Bulletin Number - BP3 Promenade - Bulletin 08

Project	Steamboat Base Village Redevelopment	Date	08/06/2021
Project Location	Steamboat, Colorado	Architect's Project Number	03.7835.000
Owner/Client	Alterra Mountain Company / East West Partners	File	6BL This is page 1 of 2
To	Saunders Construction Inc.	Attention	Bryan Sculthorpe
Address	86 Inverness Place North		
City	Englewood	State	CO Zip Code 80112
Delivered via:	<input type="checkbox"/> Messenger <input type="checkbox"/> Hand carried <input type="checkbox"/> Facsimile <input type="checkbox"/> Express <input type="checkbox"/> Pick-up <input type="checkbox"/> E-mail Address <input type="checkbox"/> Mail <input type="checkbox"/> UPS <input checked="" type="checkbox"/> Website Address BIM360

Description of Changes

1A-E1.300

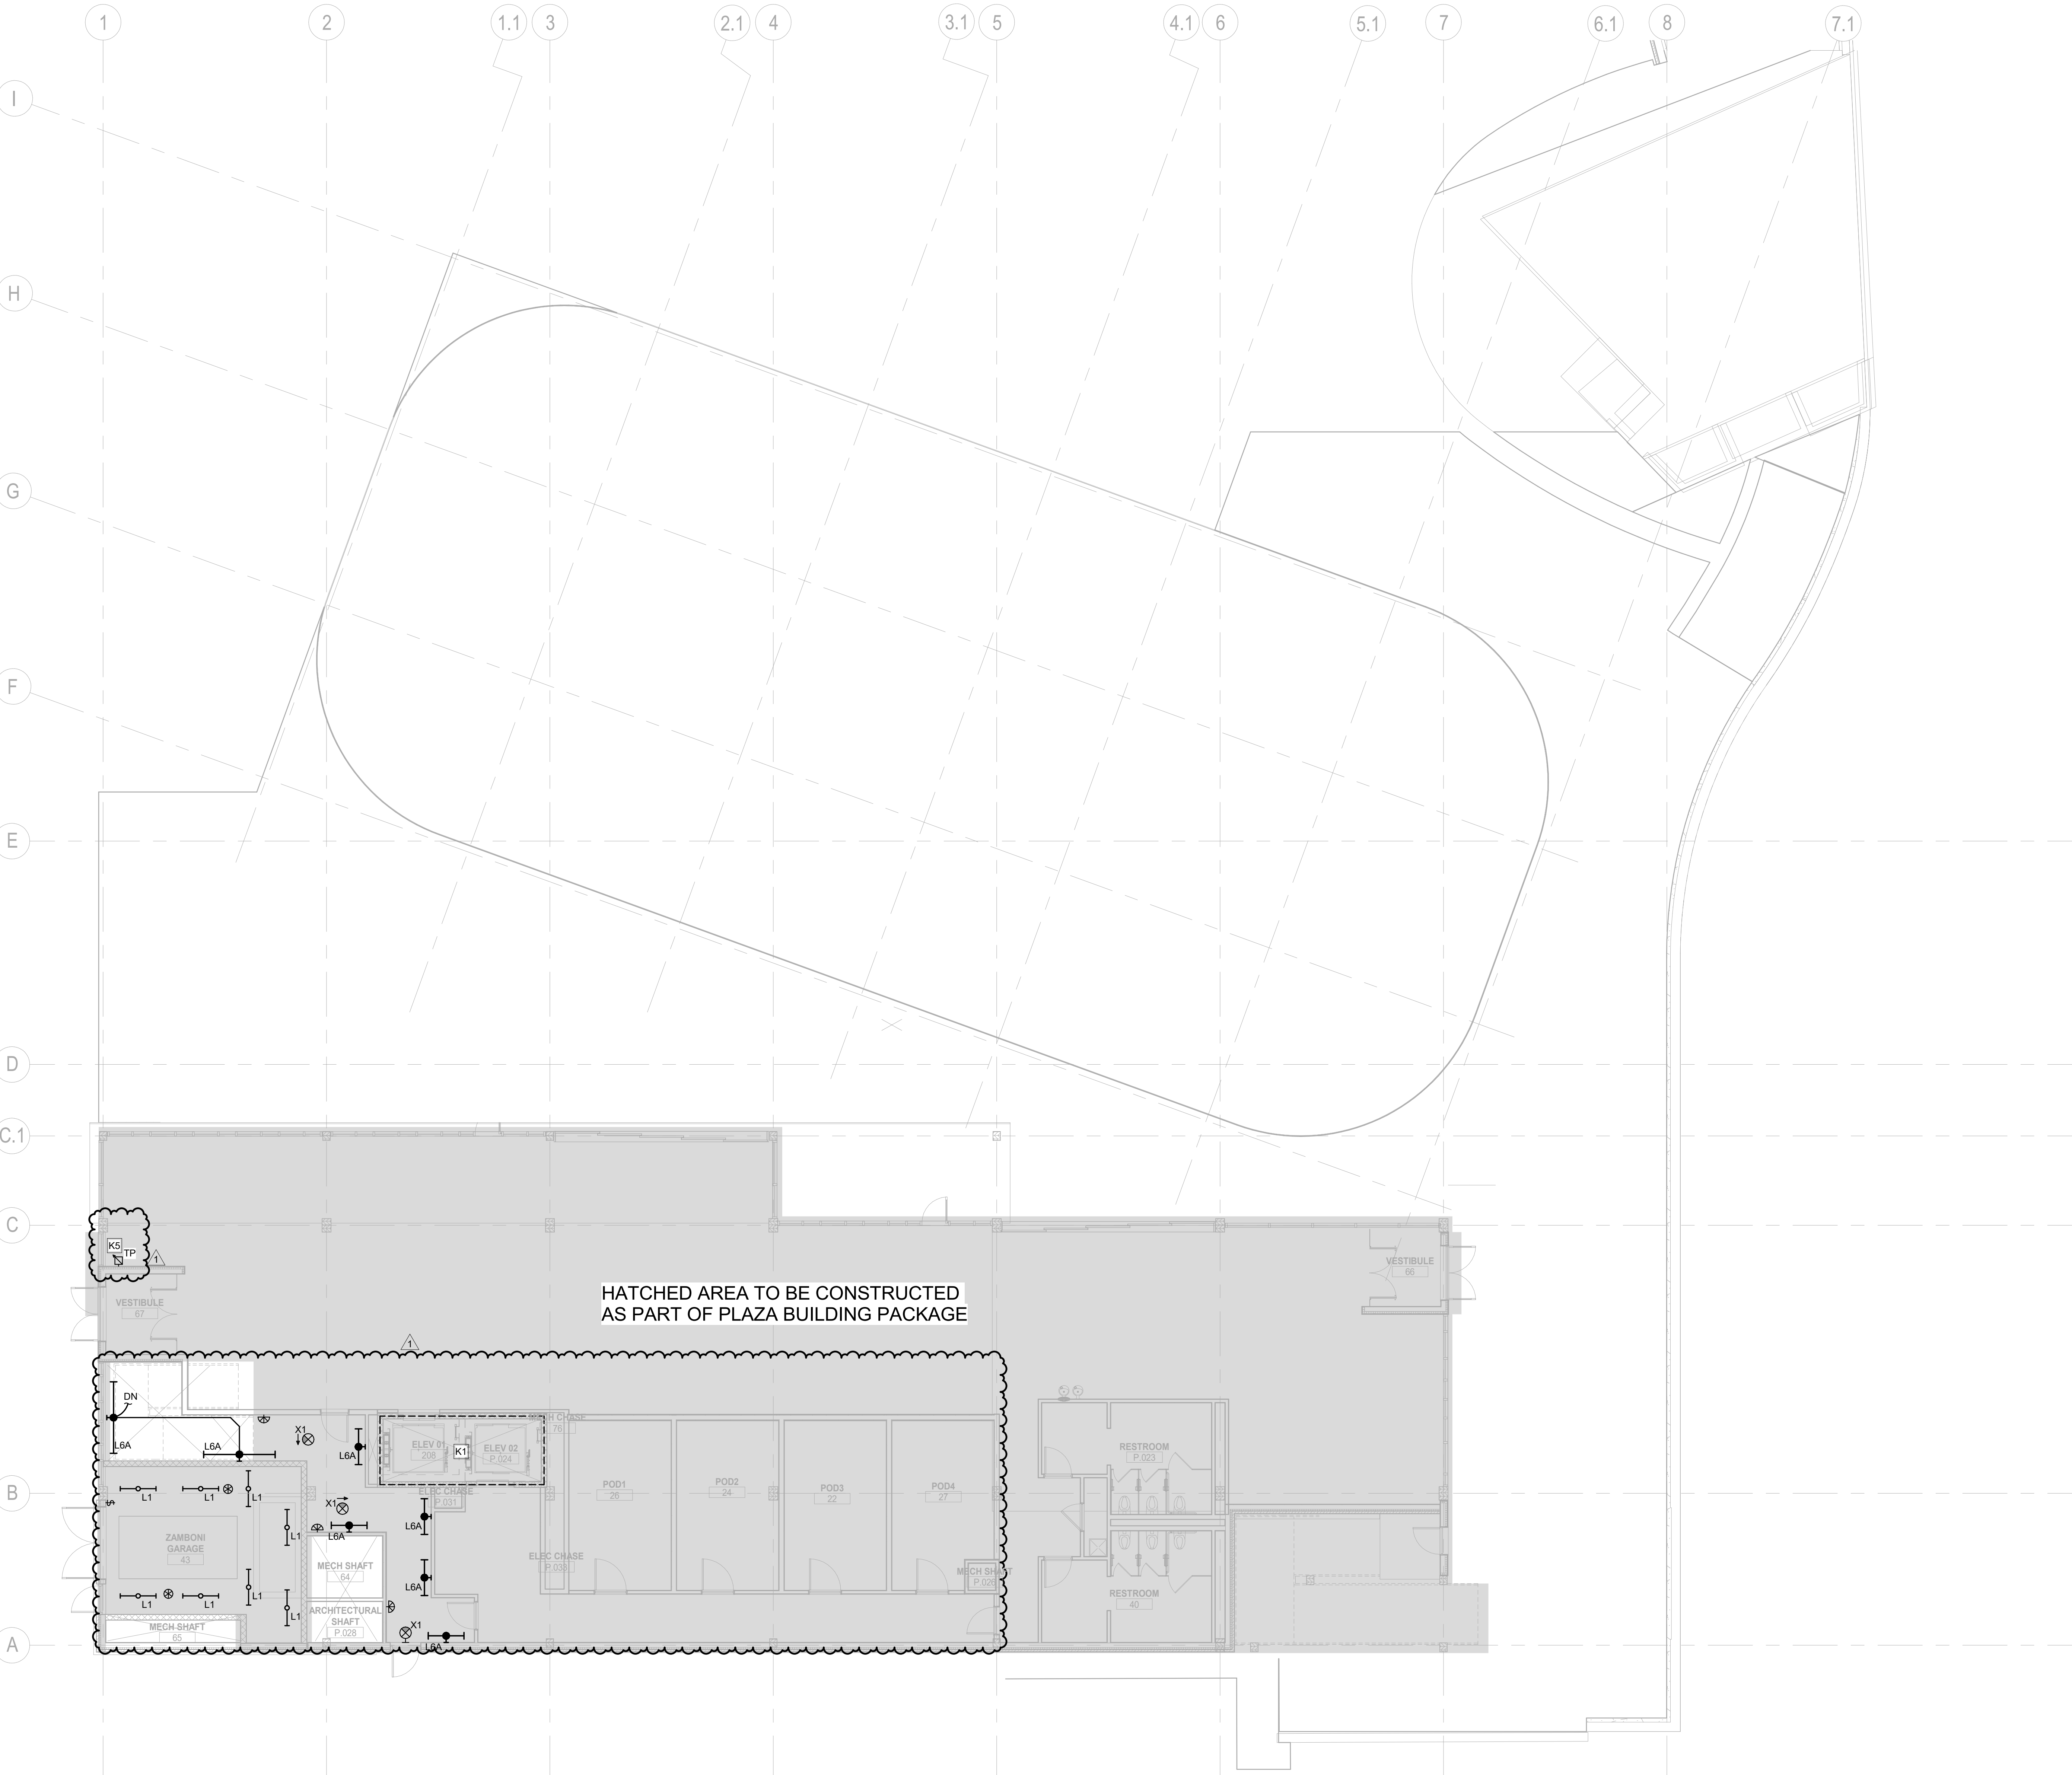
- 27. 1A-E1.300
 - a. Modified lighting fixture layout, lighting control device layout, and branch circuiting per plaza and promenade building redesign.

- b. Modified scope in gray hatch for clarity. Per conversations with Architect, any and all scope behind the gray hatch is not included in phase 1 scope of work in the field.

1A-E1.301

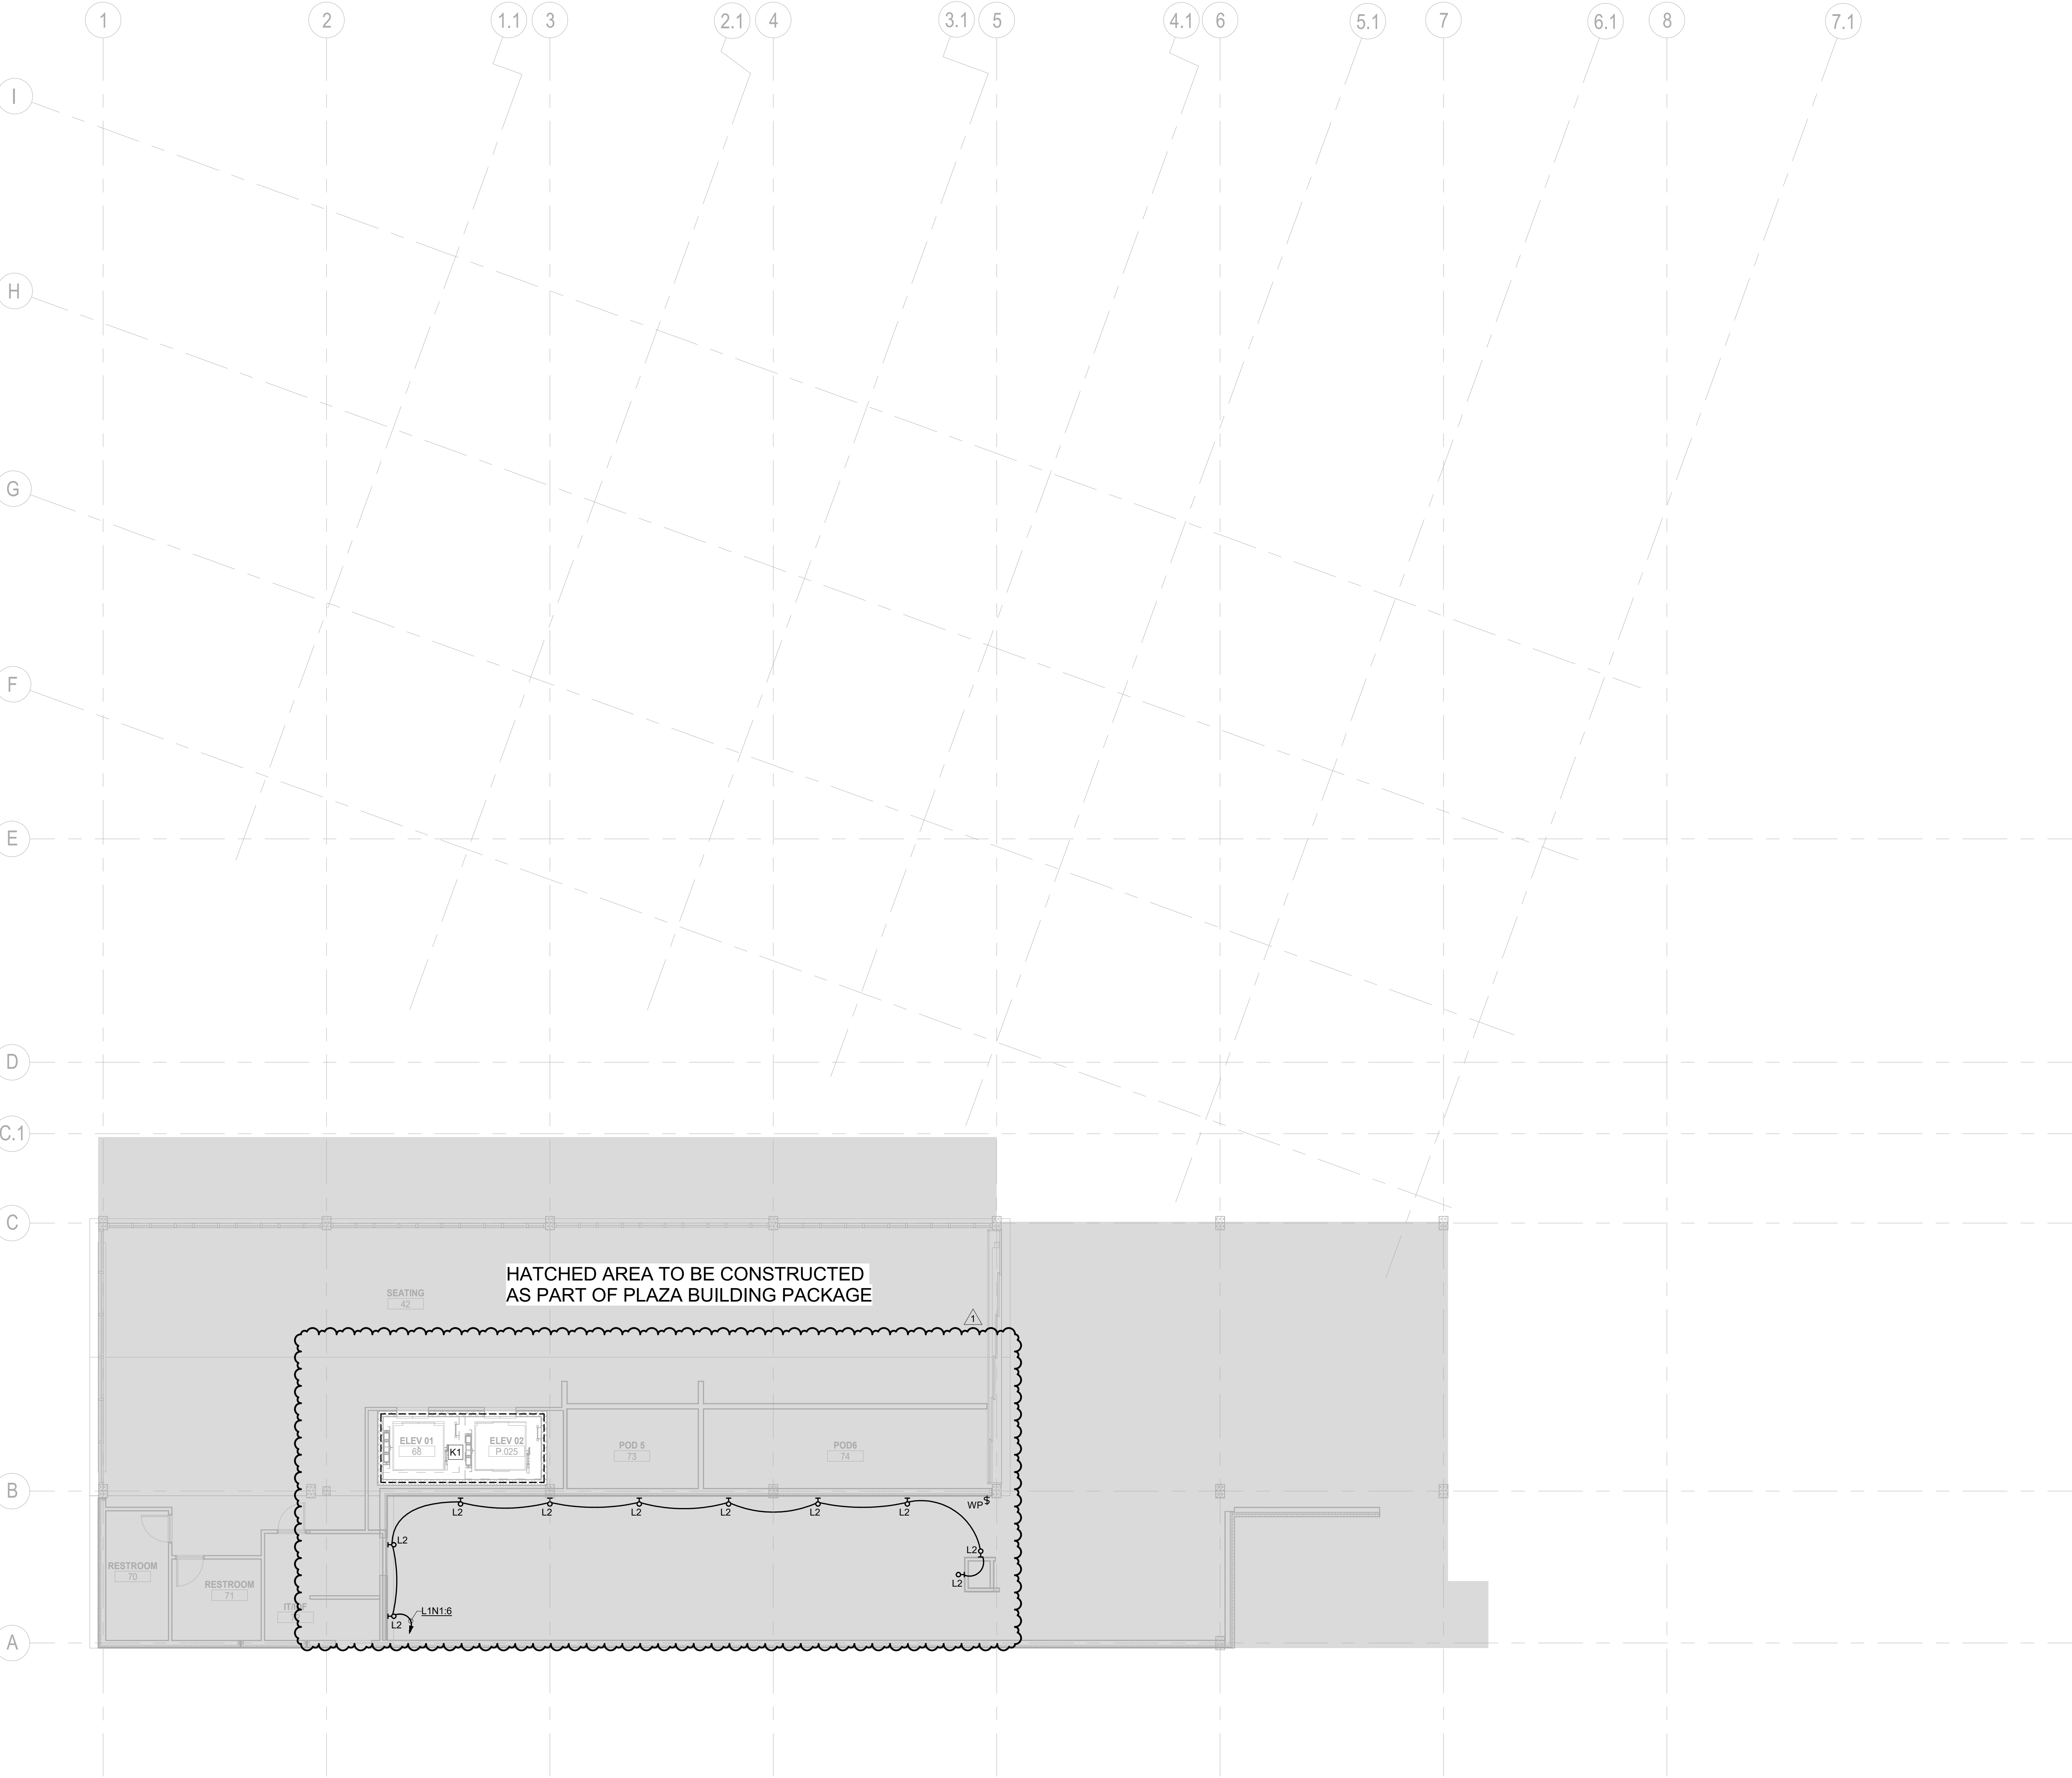
- 28. 1A-E1.301
 - a. Modified lighting fixture layout, lighting control device layout, and branch circuiting per plaza and promenade building redesign.

- b. Modified scope in gray hatch for clarity. Per conversations with Architect, any and all scope behind the gray hatch is not included in phase 1 scope of work in the field.
